January 11, 2018

Montana Department of Environmental Quality
Hard Rock Mining Bureau
Operating Permit Section
PO Box 200901
Helena, Montana 59620-0901

RE: Update to Proposed Treated Water Disposition for the Black Butte Copper Project

Figure 3.2
 Alluvial Underground Infiltration Gallery
 Black Butte Copper Project
 Meagher County, Montana

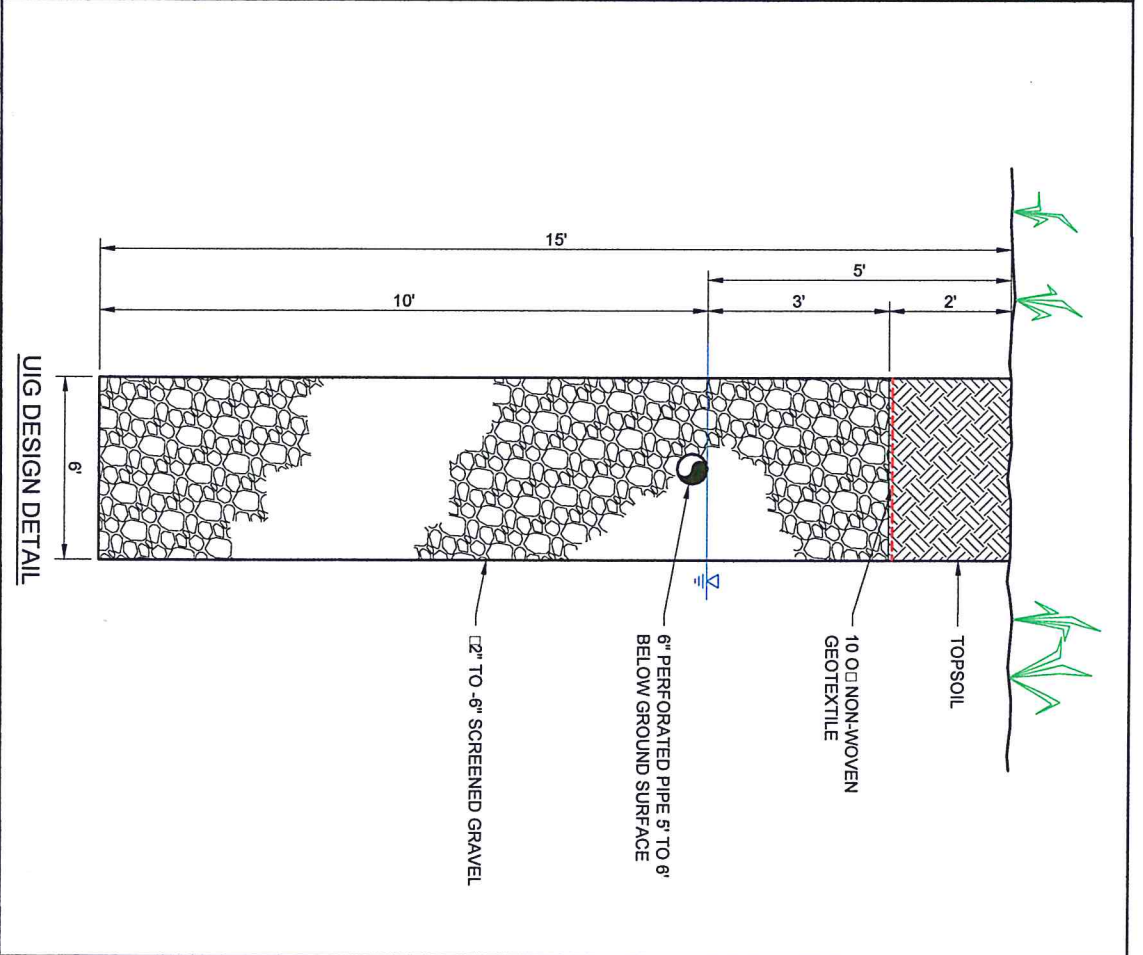
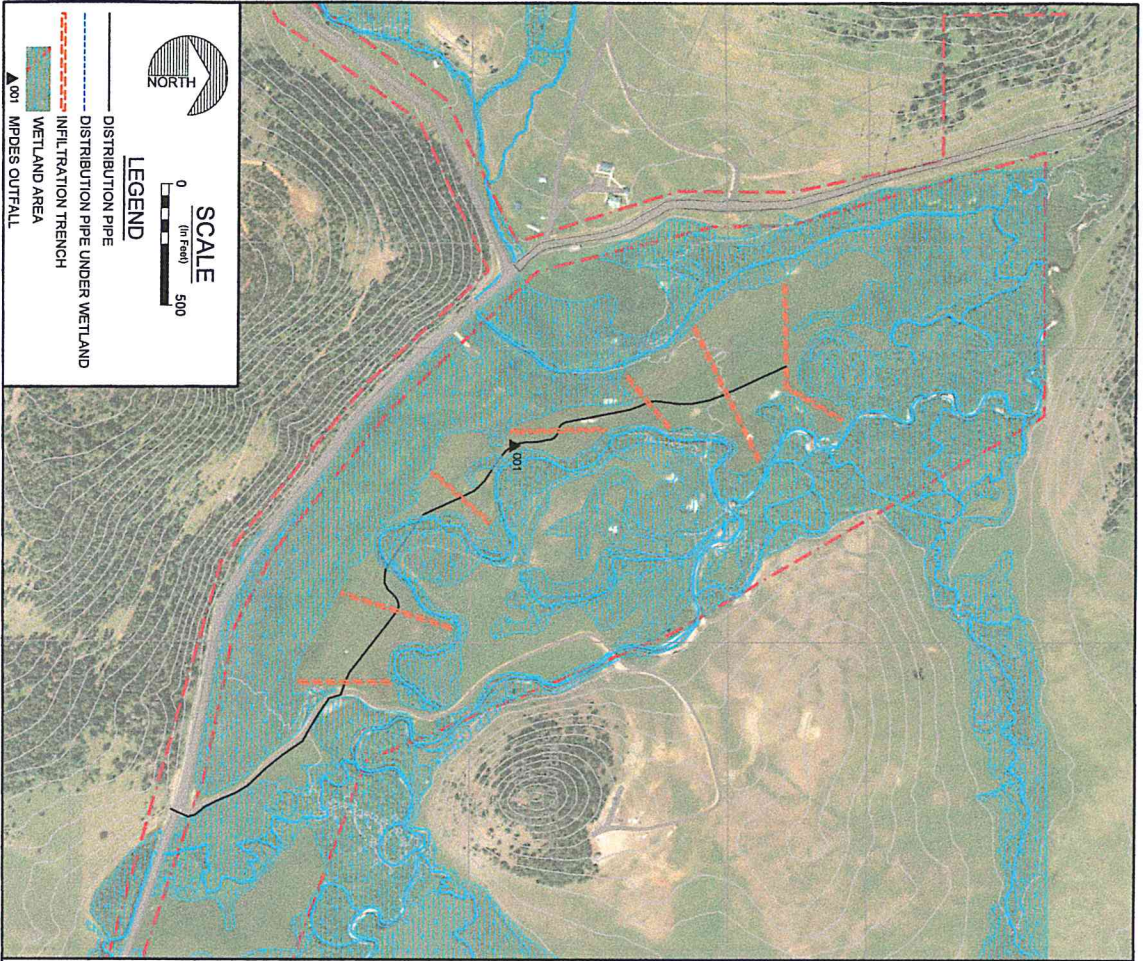
A final design of the alluvial UIG was proposed in the MPDES permit application based on the results from the infiltration testing and modeling analysis (Figure 3.2 of Discharge Permit and attached to this document). The UIG will consist of 14 individual galleries ranging between about 150 and 350 feet in length, 6 feet wide and 15 feet deep (Figure 3.2 attached). Water will be pumped directly from the Water Treatment Plant at a monitored quality that meets non-degradation criteria for groundwater and surface water. Treated water will be discharge through approximately 3,140 feet of perforated HDPE pipe within the individual galleries. Each individual gallery will have a control valve at the main distribution pipeline to allow for controlled application during operations. Tintina is evaluating options for the installation of pressure compensating emitters to insure an even distribution of water along the entire gallery length. The valves will allow water to be switched to different areas to avoid saturation of near surface soils or the formation of downgradient seeps to the surface. Water will be supplied to the UIGs through about 9,777 feet of 6-inch distribution line. The new design of the alluvial UIG is described in detail in the Integrated Discharge Permit Application Narrative (Hydrometrics, 2017).
